STAFF RECOMMENDATION
3707 Richland Avenue
December 19, 2018

Metropolitan Historic Zoning Commission
Sunnyside in Sevier Park
3000 Granny White Pike
Nashville, Tennessee 37204
Telephone: (615) 862-7970
Fax: (615) 862-7974

Application: Partial Demolition; New Construction—Addition
District: Richland-West End Neighborhood Conservation Zoning Overlay
Council District: 24
Map and Parcel Number: 10409012000
Applicant: Alex Huffstutter, Owner
Project Lead: Sean Alexander, sean.alexander@nashville.gov

Description of Project: The applicant is proposing to demolish the original roof, dormers, and gable field walls of an historic one-story house in order to increase the first story wall height and to construct a new half story with a taller roof and a steeper pitch, and to construct a rear addition.

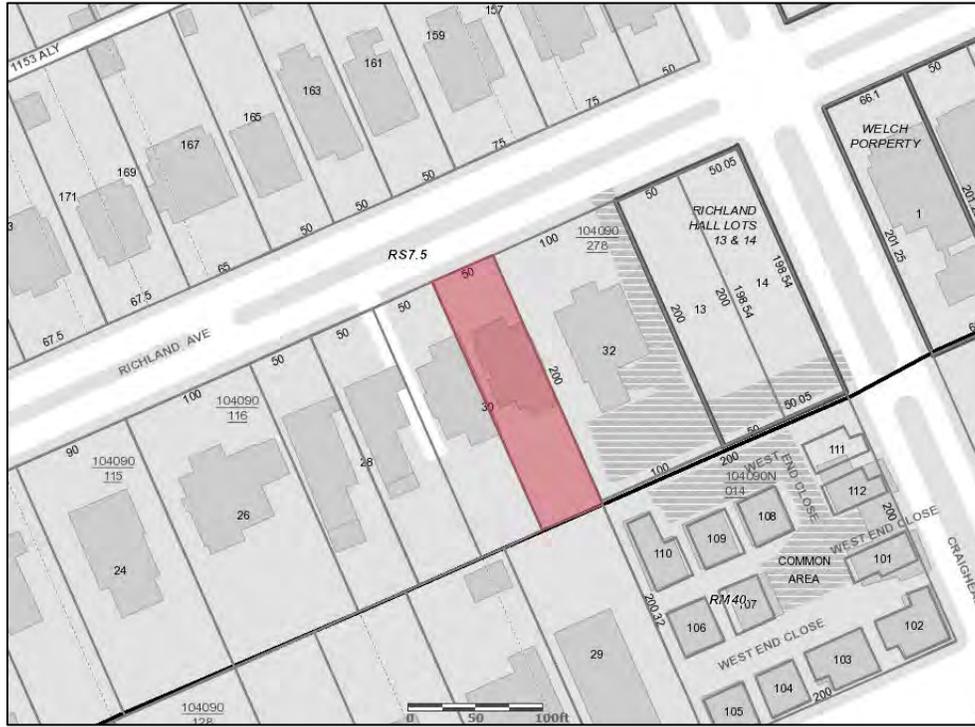
Demolition: The roof on the house consists primarily of a hipped form with a front-to-back orientation with a gabled front porch, projecting gabled bays on the left and right side, a projecting hipped rear wing, and small hipped dormers on the front and right sides. This roof form, with a 5-1/2:12 pitch on every slope, is original. The applicant proposes to remove the roof entirely, then to increase the first story wall height and construct a new roof with a taller hips and gables on the front and sides, but with an 8:12 pitch.

The roof of any building, regardless of whether it is high style or of a vernacular design, is an integral component of its architectural and historical integrity, and removing it would be severely detrimental to the building's status as contributing to the character of its surrounding neighborhood. That this roof has architectural significance is particularly evident when the architectural details like the open rafters and bracketed eaves are taken into account, especially considering the high visibility of the roof. Staff finds that the demolition of the original roof is inappropriate under section III.B.1.a of the design guidelines for the Richland-West End Neighborhood Conservation Zoning Overlay.

Furthermore, the proposal does not meet the criteria for appropriate demolition under section III.B.2.b of the design guidelines because the historic integrity of the building is intact, and demolition would not result in a more appropriate visual reflection of the district than there would be in retaining the original roof of the contributing building.

Figure 2. Right side elevations for existing (blue) and proposed (pink), illustrating the increase in first story wall height, roof pitch, and roof height.

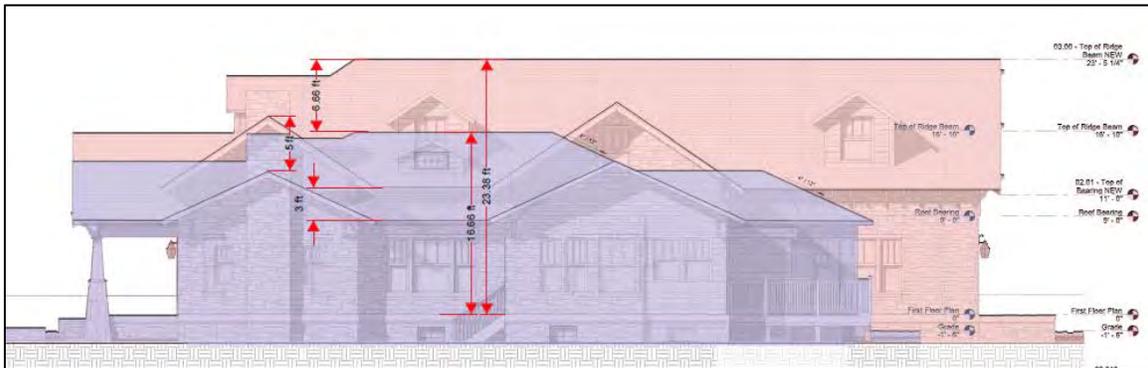
Location & Removability: After demolishing the existing roof and dormers, the proposal would extend the height of the first story walls up three feet (3') and construct a new roof with a steeper pitch than the original. The eave height would increase by three feet (3'), the height of the side gables would increase by five feet (5'), and the height of the primary hipped roof would increase six feet, eight inches (6'-8").

This change would be an irreversible alteration of the original massing of the house, and would drastically change the appearance of the house as viewed from the front and sides. Staff finds that the addition does not meet sections II.B.2.a and II.B.2.d of the design guidelines.

Height & Scale: As described previously, the proposal would increase the eave height by three feet (3'), the height of the side gables by five feet (5'), and the height of the primary hipped roof by six feet, eight inches (6'-8"). The new upperstory would have projecting hips and gables with dormers on the front and sides but where the existing roof has a hip the proposal would extend back with a rear-oriented gable at the new height six feet, eight inches (6'-8") taller than the historic house. Because the new roof is taller and dependent on the demolition of the existing roof, staff finds that it is not compatible with the historic house and does not meet Sections II.B.1.a and II.B.1.b of the design guidelines.

roof plan
1/8" = 1'-0"

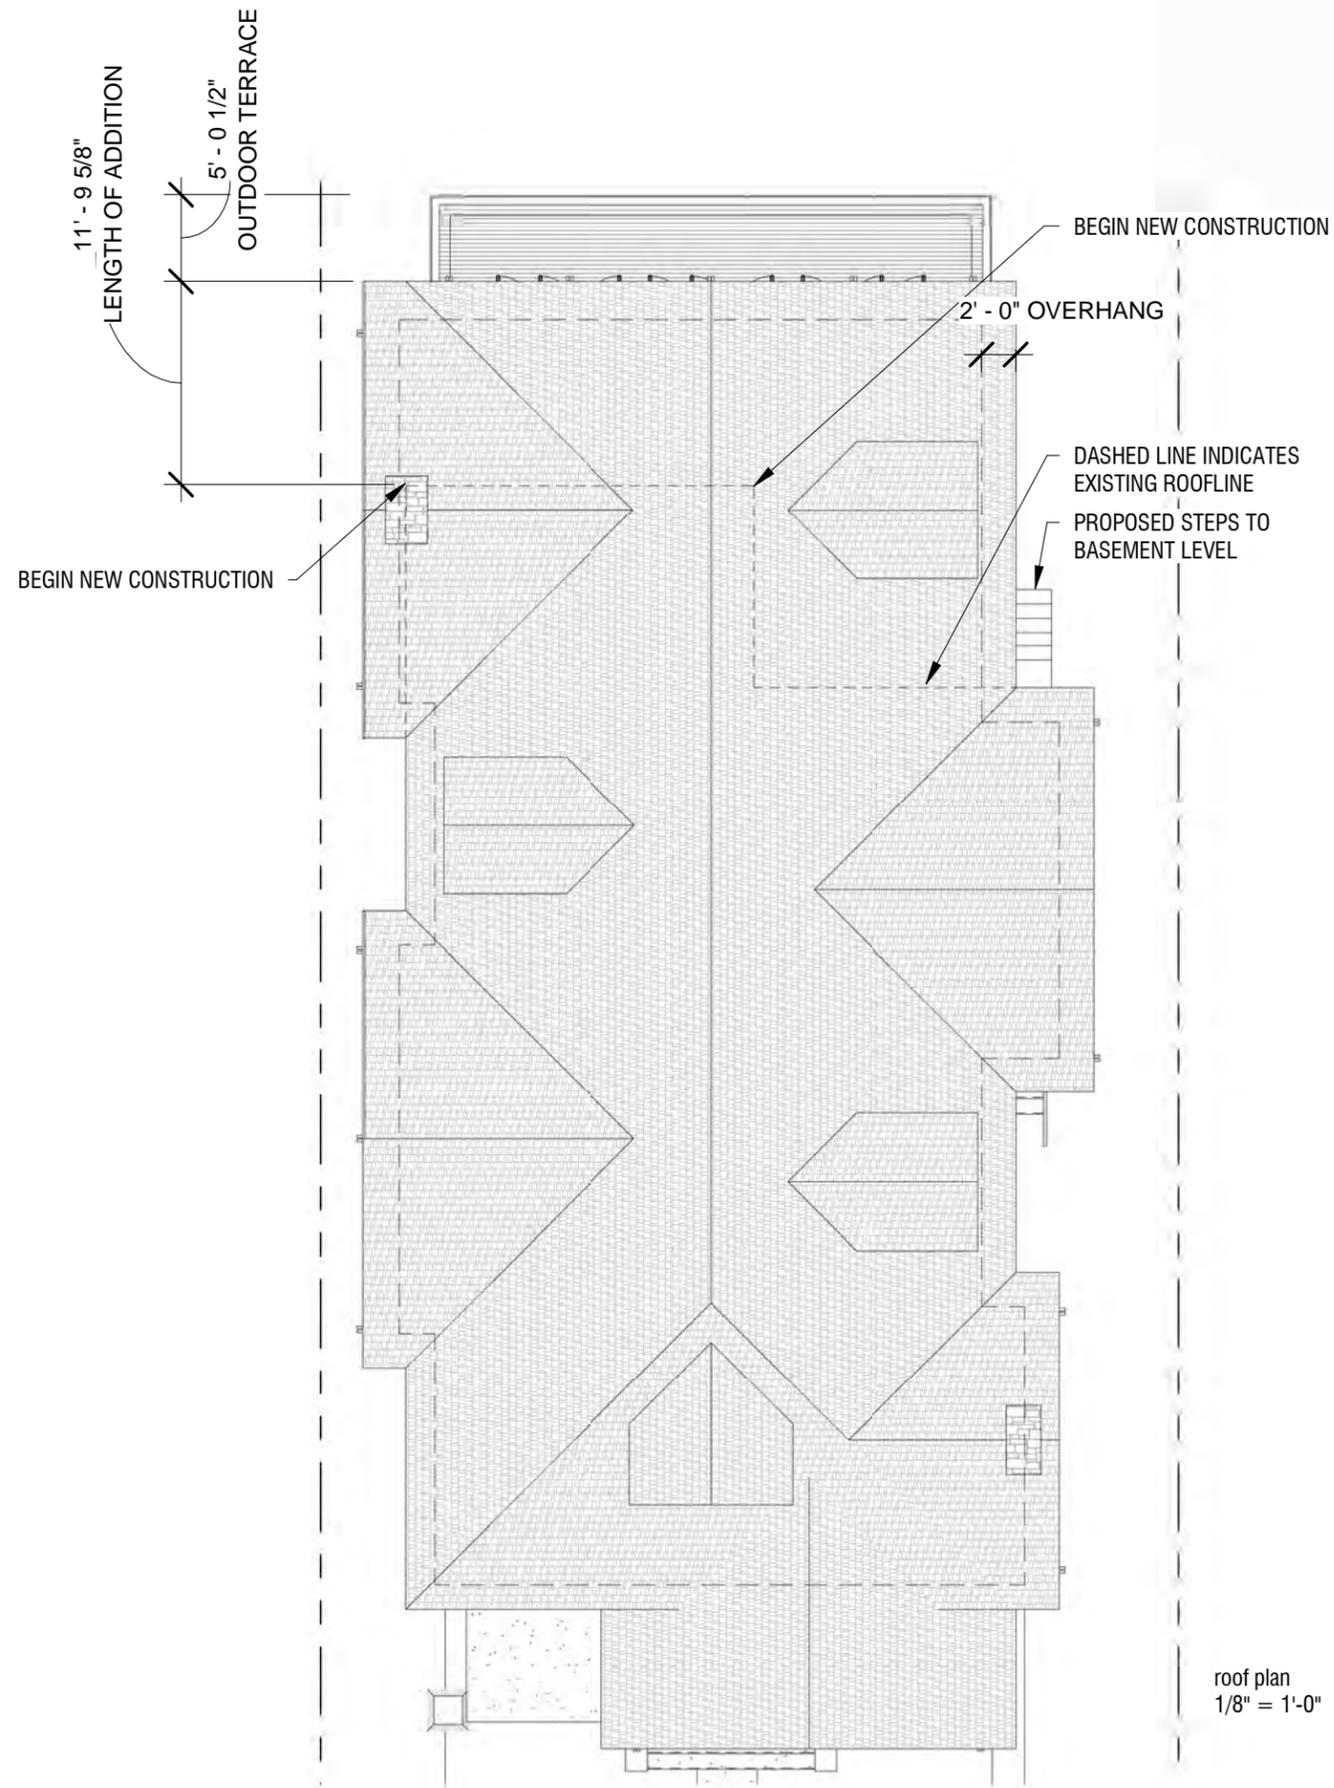
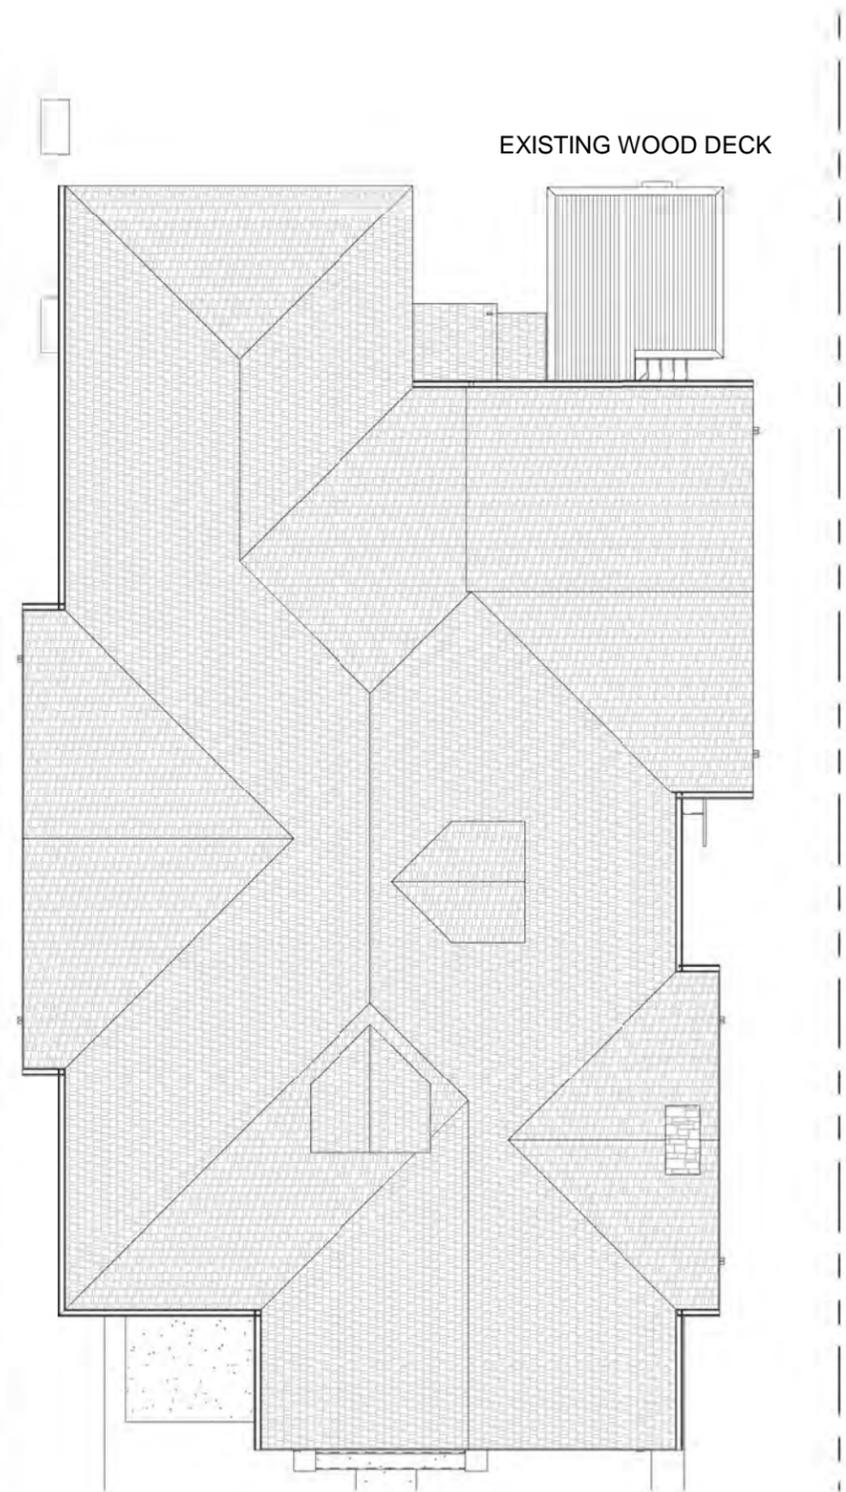
Roof form: In addition to demolishing the roof and dormers to increase the first story wall height and construct a steeper roof, the project includes a rear addition that would not be differentiated from the original roof form, effectively changing the rear from a hip to a gable. Although hips and gables could be compatible with the age and style of the house, the proposed addition cannot be considered independent of the inappropriate demolition. Staff therefore finds that the proposal is not compatible with the historic house and that the project does not meet Section II.B.1.e of the design guidelines.
